Chapter 7 Wall Covering

FIGURE R703.7(1)
HOLD DOWNS AT EXTERIOR AND INTERIOR BRACED WALL PANELS
WHEN USING STONE OR MASONRY VENEER

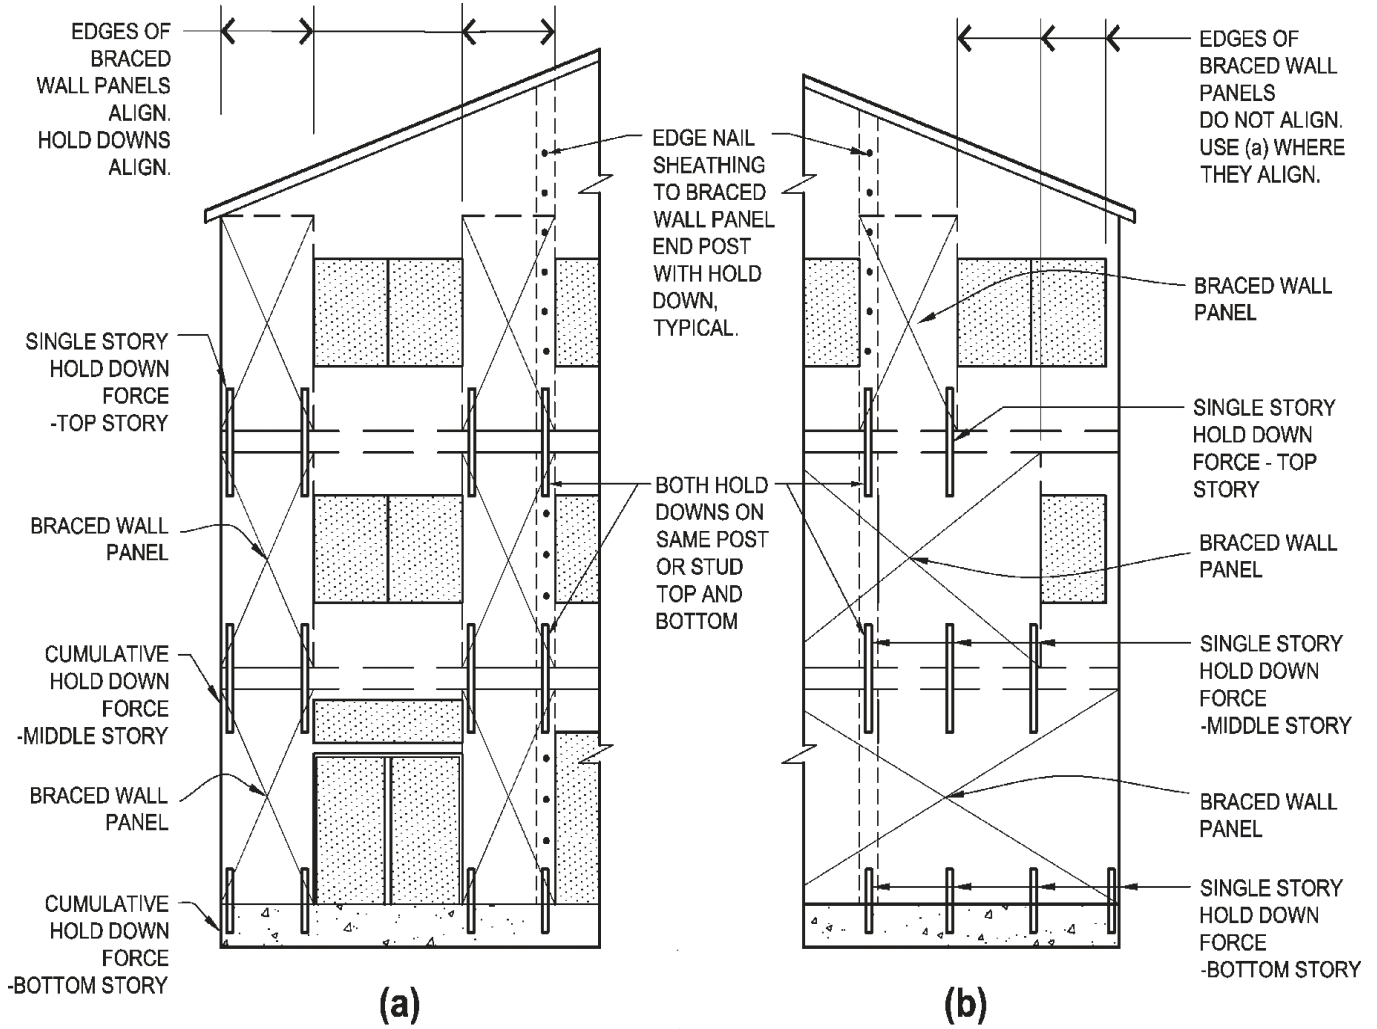
New Figure

- (a) Braced wall panels stacked (aligned story to story). Use cumulative hold down force.
- (b) Braced wall panels not stacked. Use single story hold down force.
